Planning Permit Officer Report

PA2403211: 11-17, 19, 21, 23 and 25-27 Dorcas Street,
South Melbourne

Planning Permit Officer Report
Development Approvals & Design

Department
of Transport
and Planning

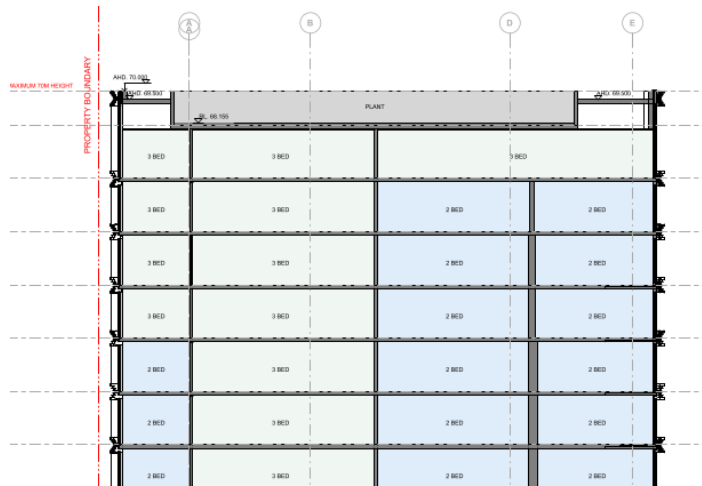
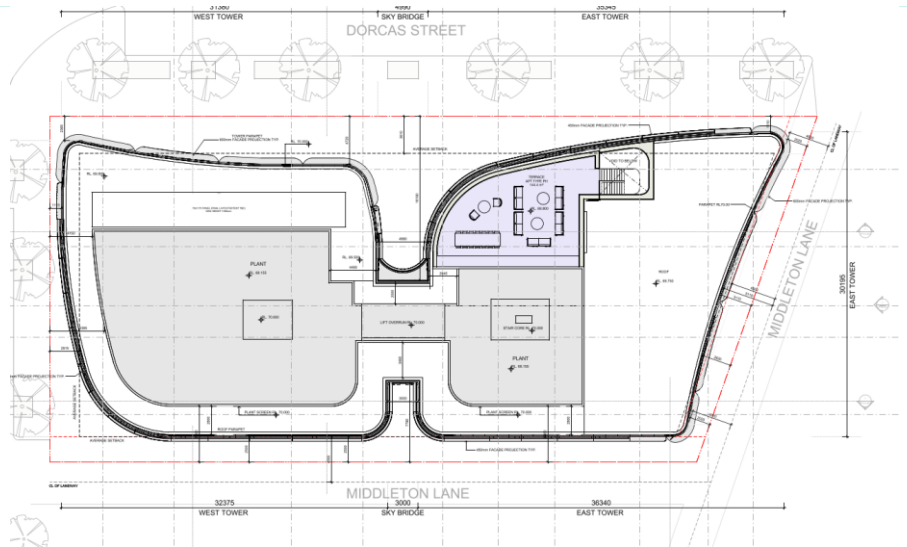
- While the width of the tower along Dorcas Street is wider than 35m, the upper form has been designed to appear as two distinct yet related tower forms. Each tower element is approximately 32-34m in width along Dorcas Street. While this does not strictly meet the (discretionary) tower width of 35m required, it is acceptable as the design successfully maintains sightlines between buildings and creating a perception of two towers from the public realm.

Figure 13: Setbacks of the tower from each property boundary

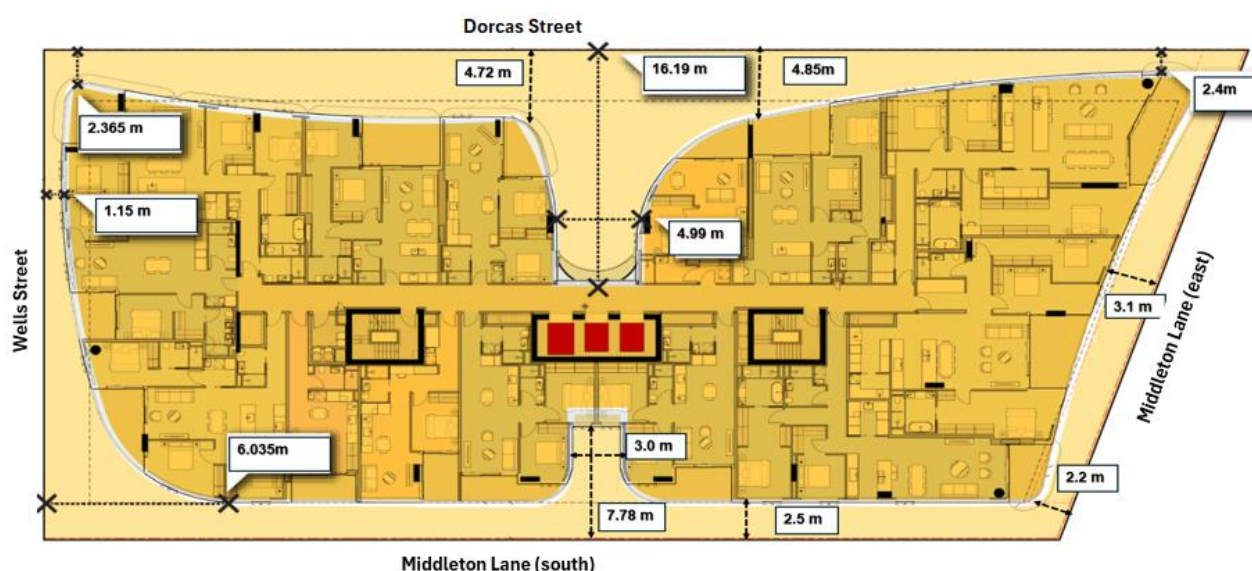
68. In response to the eastern interface, the proposed tower would have a curved form with a setback between 2.2 to 3.1m from the eastern property boundary. The tower will be set back a minimum of 4.5m from the centre of Middleton Lane. While the edges of the tower will not be setback 4.5 metres (as required by DDO26), it is considered that the tower setback is acceptable in this instance given only a small part of the tower would encroach into the 4.5m setback. The varying setbacks of the tower will create visual interest and ensure the podium remains the dominant built form element in the streetscape.

69. In response to the rear interface, the tower is proposed with a 2.5 setback from the property boundary and 4.5m from Middleton Lane. This will ensure a 9m setback to any future tower form at 145-149 Wells Street allowing for an appropriate physical break and the protection of the reasonable amenity expectations of future residents.

Figure 18: Doors opening to Middleton Lane will obstruct laneway

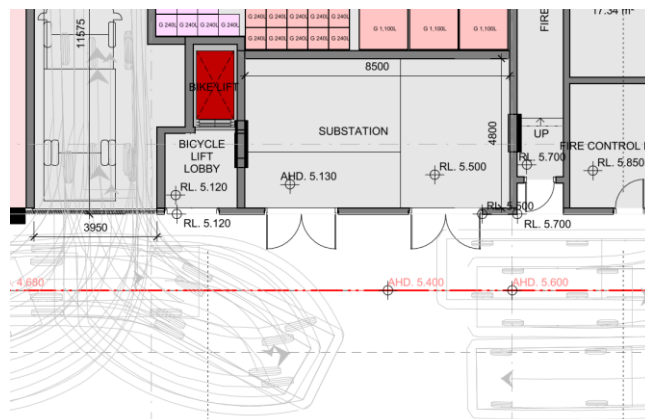
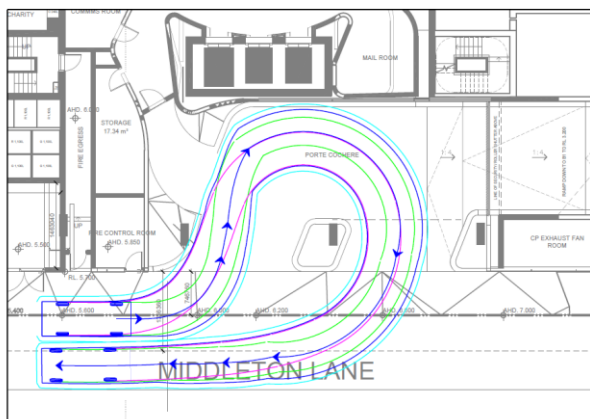
119. Access to the loading bay and car parking areas will be provided via Middleton Lane (south).
120. It is expected Middleton Lane (south) will carry up to 37 vehicle movements and Middleton Lane (east) will carry up to 24 vehicle movements per hour post-development (two-way, split between in and out movements). Middleton Lane (south) is currently 4.2m but will be widened to 6.1m between the porte cochère and Wells Street to facilitate two-way traffic movements post development. It however appears that the doors to the substation, which open onto Middleton Street will obstruct the laneway. A condition on any approval will require the doors of the substation open to the inside so that it does not obstruct the laneway (see Figure 18).
